Radiation Tolerant FIFOs

M67206F

M672061F

Errata Sheet

Figure 1. Behavior Description

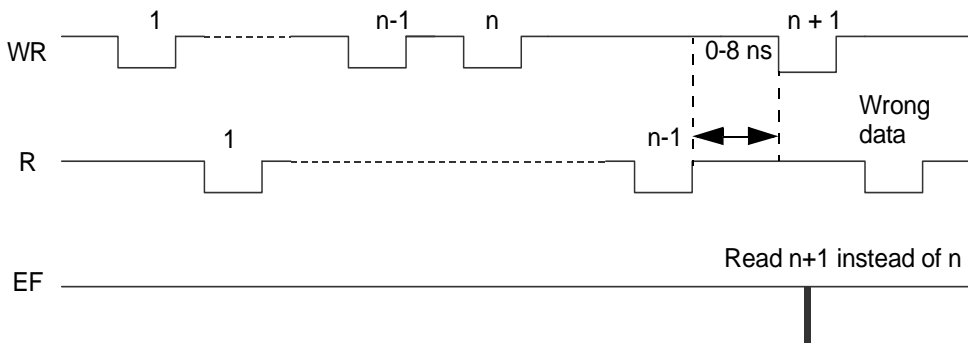
1. Limitation to the operating conditions inside a timing and data marginal configuration.

Rising edge of READ from 0 ns up to 8 ns (typical) before the falling edge of WRITE when only one data is left to read.

See Figure 1 for behavior description.

Empty flag glitch and following data shift out 2nd byte corruption occurs when the rising edge of the first "READ" for data shift out occurs before falling edge of the third "WRITE" for data shift in.

between 0 ns and 11 ns

Temperature = 125°C

Voltage = 4.5V

These FIFOs are functional outside of the above timing and data marginal configuration.

The recommended action is to avoid this particular configuration.
